REVISED RESPONSE TO REQUEST FOR ADDITIONAL INFORMATION

APR1400 Design Certification

Docket No. 52-046

RAI No.: 227-8274
SRP Section: 03.08.04 – Other Seismic Category I Structures
Application Section: 03.08.04
Date of RAI Issue: 09/25/2015

Figure 1 Static Lateral Pressure

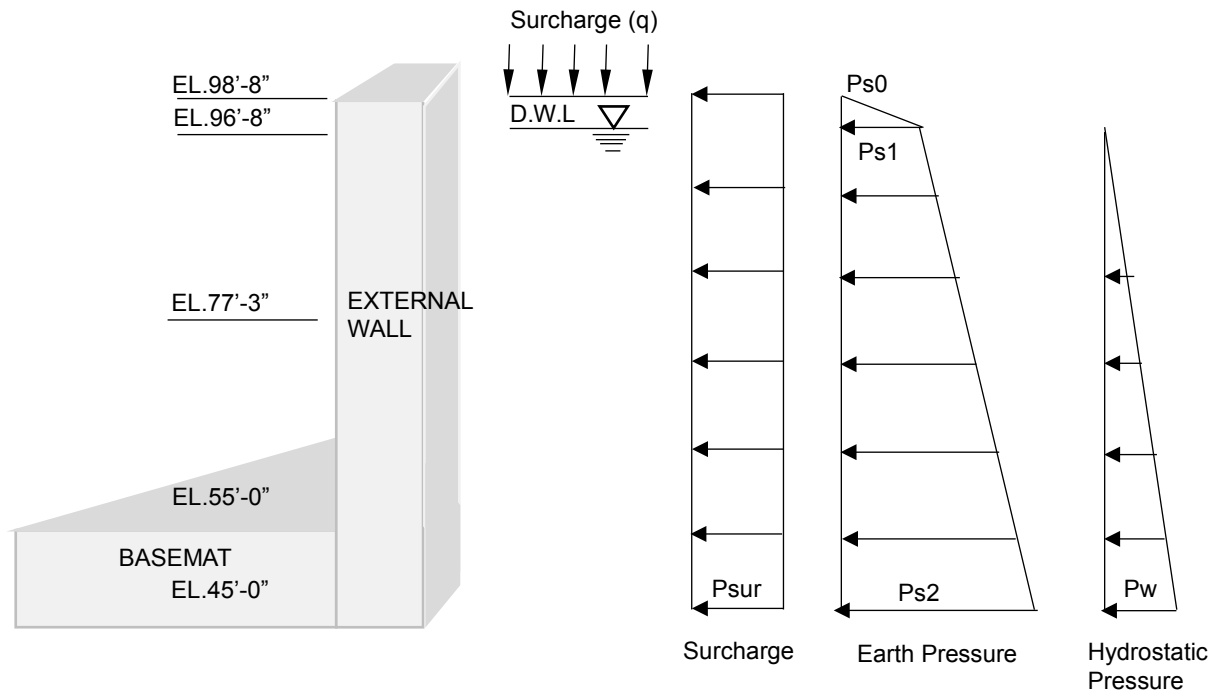
Applicant is requested to describe how the various water/flood related loads are classified (e.g., normal, severe environmental, abnormal, etc.), how they are calculated in terms of the loads used in DCD Section 3.8.4, how are they applied in the design of seismic Category I structures,

The soil and surcharge load (L_g) include hydrostatic pressure, surcharge load, and earth pressure. Hydrostatic pressure is applied up to elevation of groundwater specified in DCD Tier 2 Table 2.0-1 (0.61m (2 ft) below plant grade). Earth pressures are applied up to the grade level, as shown in the Figure 1.

Hydrostatic loads are calculated as a linearly distributed pressure on external walls depending on the design water level (EL. 96'-8") according to the basic equation of hydrostatics as shown in Figure 1. [The design groundwater elevation for the APR1400 standard plant design is based on the EPRI ALWR URD \(Utility Requirement Document\) Table 1.2-6 "Envelope of ALWR Plant Site Design Parameter."](#) Therefore, the maximum design ground water level is determined to be 0.61m (2 feet) below the plant grade in the vicinity of the SSSc important to safety, (see the applicant's response to RAI 75-8023 Question 03.04.02-1 item a. (ii)).
